Access Compliance Report

Intersection ID: 7616	Main Street: GEORGETOWN_DR	Cross Street: SPRING_GARDEN_LN	Location: SW
ADA ID: 717033CD1DAB	Ramp Type: Perp	Initial Pass/Fail: Fail	Overall Compliance: No
Severity Score: 21.25			
Codes/Mitigation Info/Possible Solution		Field Measurements/Component Compliance

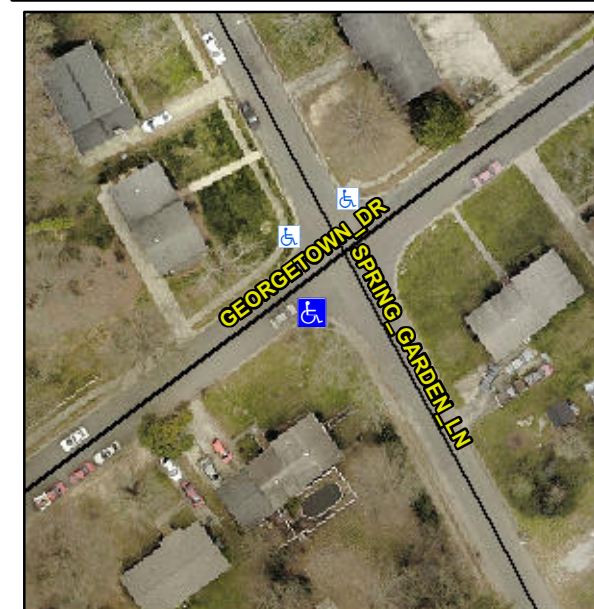
Not Found, R304.5.1, R304.2.2

Compliance	Description	Data	Compliance	Description	Data
N/A	Ramp Length (in)	47.5	No	Ramp Slope (%)	10.8
No	Ramp Width (in)	42.0	Yes	Ramp XSlope (%)	0.6
N/A	Flare Type LT	N/A	N/A	Flare Type RT	N/A
N/A	Flare Slope LT (%)	N/A	N/A	Flare Slope RT (%)	N/A
N/A	Flare Traversable LT?	N/A	N/A	Flare Traversable RT?	N/A
N/A	Landing Length (in)	N/A	N/A	DWS Provided?	N/A
N/A	Landing Width (in)	N/A	N/A	DWS Contrast?	N/A
N/A	Landing Slope (%)	N/A	N/A	DWS Length (in)	N/A
N/A	Landing X Slope (%)	N/A	N/A	DWS Full Width?	N/A
N/A	Landing Curb? (Y/N)	N/A	N/A	DWS Offset (in)	N/A
N/A	Shared Landing?	N/A			
N/A	Gutter Ponding?	N/A	N/A	Gutter Slope (%)	N/A
N/A	Gutter Lip Ht (in)	0.5	N/A	Gutter X Slope (%)	N/A
N/A	Painted X Walk1?	No	N/A	Painted X Walk2?	N/A
	X Walk 1 Direction	To NW		X Walk 2 Direction	N/A
N/A	X Walk 1 Width (in)	N/A	N/A	X Walk 2 Width (in)	N/A
	X Walk 1 Slope (%)	0.0		X Walk 2 Slope (%)	N/A
	X Walk 1 X Slope (%)	3.1		X Walk 2 X Slope (%)	N/A

Remove & Replace Entire Ramp.
